SUBJECT: VOIDED APPLICATION

Re: Control Number 86788  
License No. 12-16941-01

In accordance with your telephone reminder yesterday, the following information is provided to address the concerns expressed in Cassandra Frazier's letter dated June 12, 1989, regarding Professional Service Industries' proposed modification to the handles of Campbell Pacific Nuclear "Portaprobe" moisture density gauges (models MC-1, MC-2 & MC-3) in our inventory.

5

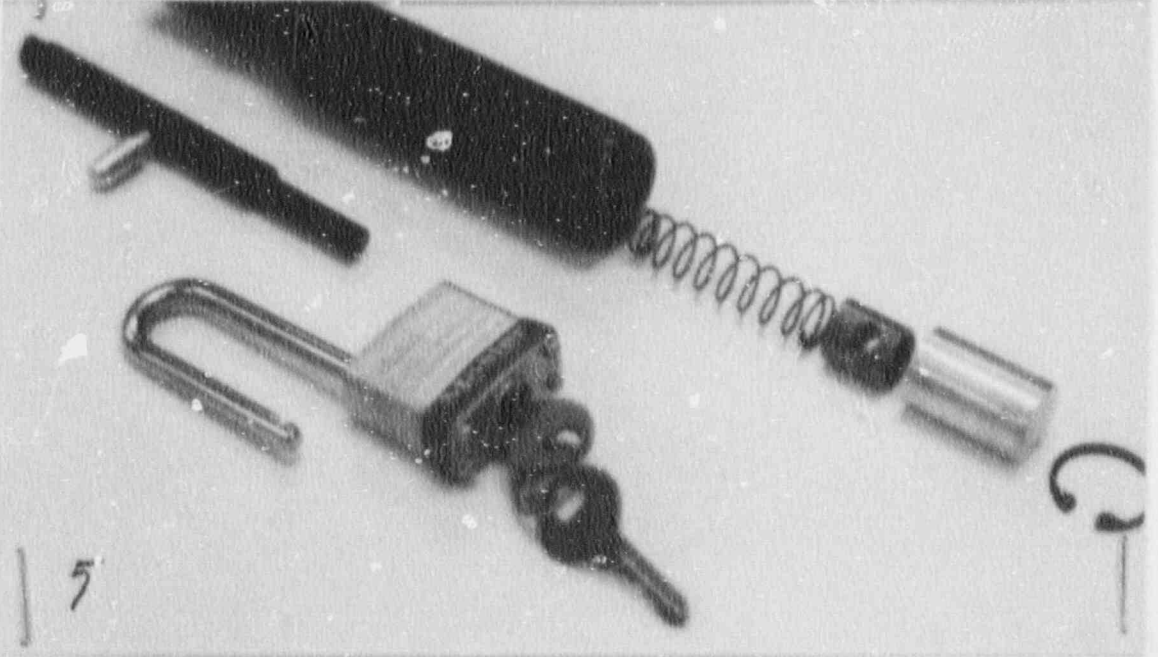
- 1 typical breakage at weakest point
- 2 broken handle, disassembled
- 3 intact and broken locking pins
- 4 two handles depicting identical point of failure
- 5 disassembled modified handle
- 6 disassembled modified handle, alternate view

2. Destructive tests of the modified handle demonstrate that the handle is not weakened by the modification; when stressed, the handle breaks where it has "historically" broken. Enclosed photographs evidence these failures. Since no changes have been made in the locking pin, trigger or the source rod indexing for the manufacturer's safe, shielded position, the shielding provided for DOT Spec 7A package qualification has not been affected, either positively or negatively. This is verified after each installation by the performance standard addressed below, in item 3.b.

The annotated drawing is provided to identify each part in the photographs, and to depict their relationships when assembled. The copper spring retainer is friction-fit and restrained by an aluminum plug, together filling the void left by the removal of the manufacturer's plunge lock. The "C"-clip and allen screw are retained manufacturer's provisions, locking the aluminum plug in place.
